Piper Aircraft, Inc.
 2926 Piper Drive
 Vero Beach, FL, U.S.A. 32960

SERVICE NO. 1331A LETTER

Service Letter (SL) 1331A supercedes SL 1331 in its entirety. Aircraft that were previously made compliant with SL 1331 are in compliance with SL 1331A.

IMPROVED SPRING ATTACHMENT PLATE

Figure 1
Spring Attachment Plate Installation
(PA-44-180 shown, other models similar)

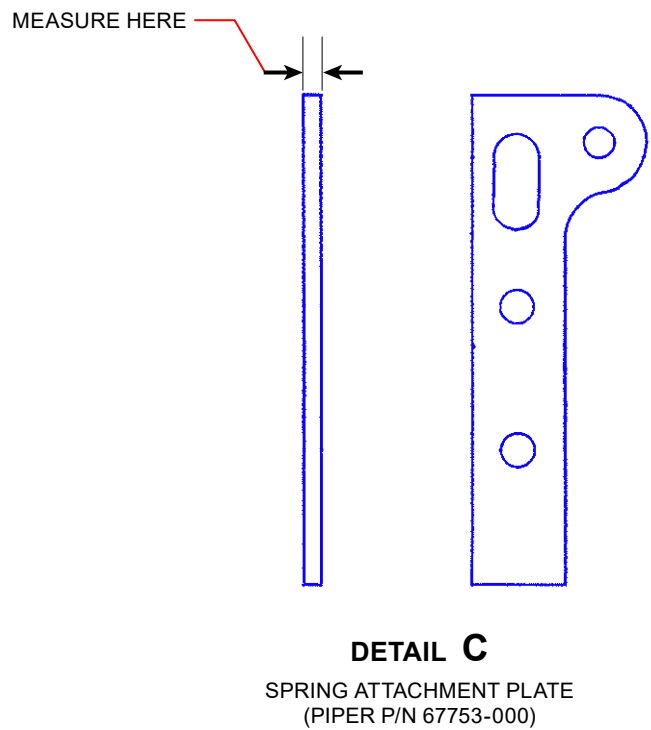
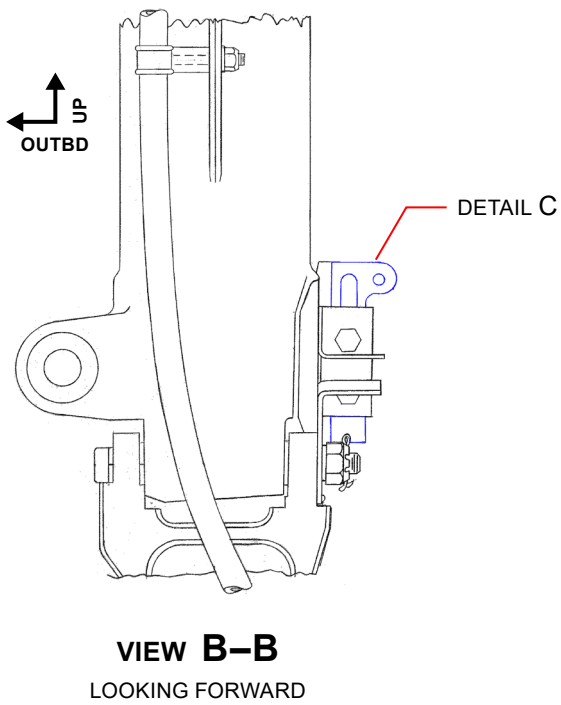
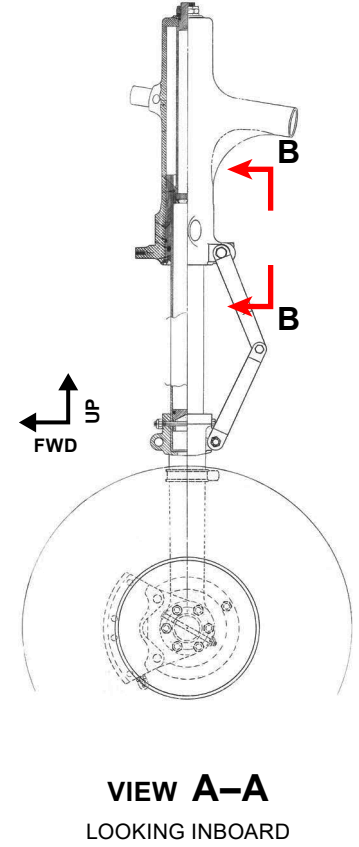
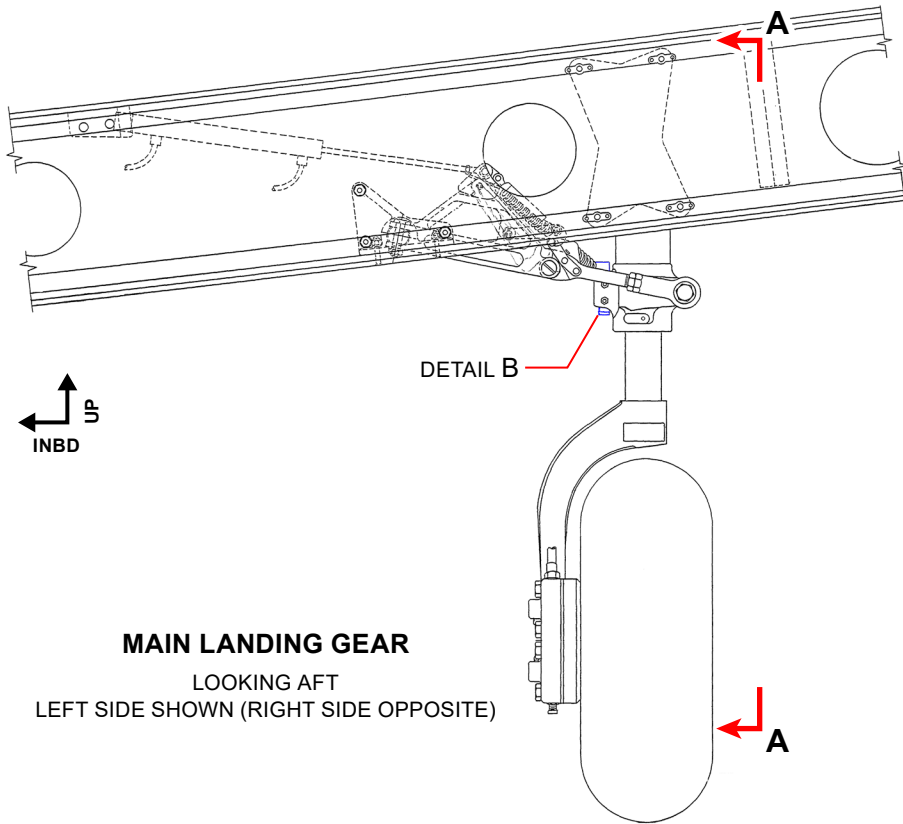
- a. Locate the spring attachment plate on each main landing gear as shown in Figure 1.
 - b. Measure the material thickness of each spring attachment plate.

- If the thickness of the plate is 0.090 inches, no further action is required; proceed to step 3.
 - If the thickness of the plate is 0.063 inches, further action is required; proceed to step 2.

2. Order and replace the spring attachment plates, Piper P/N 67753-000. Refer to Chapter 32-10-00 of the applicable Piper airplane maintenance manual (AMM) or the appropriate section of the applicable Piper service manual (SM) for instructions on removal and installation of main landing gear components. Replace fastener hardware on condition.
NOTE: Refer to the section index guide of the applicable service manual; the section on retractable landing gear varies between each Piper SM.
